# ADMINISTRATIVE DETERMINATION & CERTIFICATION

## FINAL PLAT

Langston Commons

**PF-15-00405:** Final Plat for Langston Commons, a 19.19 acre lot for future neighborhood commercial development located on the northeast corner of K-10 Highway and Bob Billings Parkway. Submitted by BG Consultants, for RSR Holdings LLC, property owner of record.

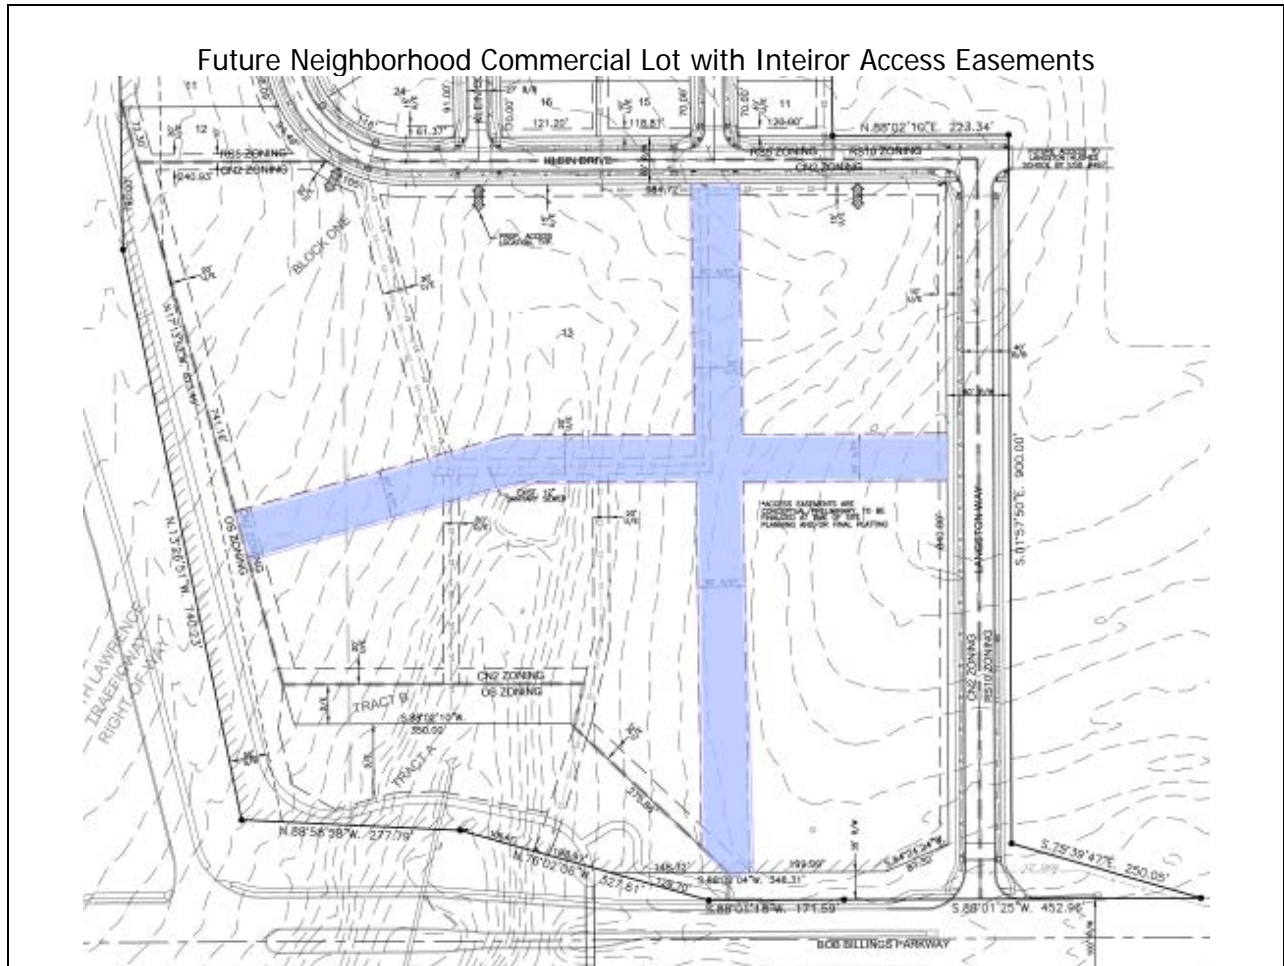
The Final Plat conforms to the approved Preliminary Plat; except the Final Plat, as proposed, does not include interior access easements as were shown on the approved Preliminary Plat. See discussion below.

At this time Langston Commons is proposed as a single lot. Interior streets are not proposed. The approved Preliminary Plat included interior access easements that are not included in the final plat. Interior access was shown on the Preliminary Plat in response to review comments of the project with the acknowledgement that they may change as details of development are confirmed. Given the uncertainty of the future development and the likelihood of vacation of the access easements to align with a future development plan, the applicant's design team proposes to defer the dedication of interior access easement to be determined with the submission of a future site plan.

Future subdivision of the lot may be considered. Interior access could be provided via a public street or shared access easements as applicable to future development of the lot. An interior access easement may also be dedicated by separate instrument concurrent with a future site plan for the development of the lot.

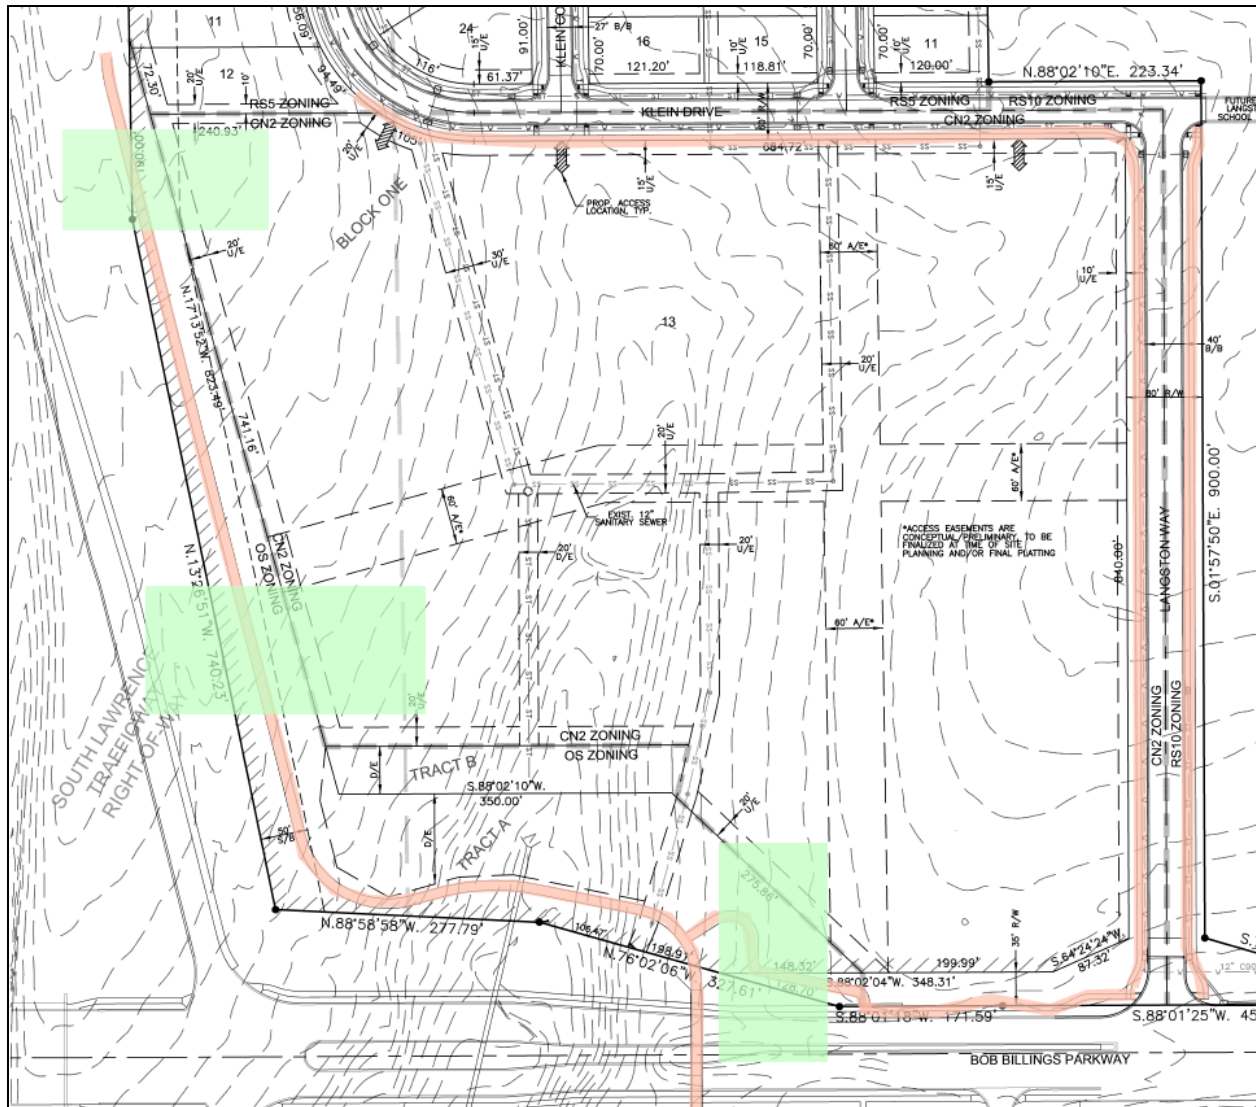
Tract A is noted as "privately owned" with a permeant easement conveyed to KDOT for the purposes of controlled highway access and highway construction. This easement does not prohibit access to the shared-use path. The exact location and alignment of the multi-purpose recreation path and the connection between the path and future commercial development are undefined at this time. A condition of commercial development of this property will include the provision of the pedestrian connection. Unlike the residential connections to the north this connection can be deferred until such time as the commercial development pattern is more defined. Residential development requires the constriction of the pedestrian connections as part of the public improvements. One or more pedestrian connections are anticipated between the commercial development and the peripheral public sidewalk facilities.
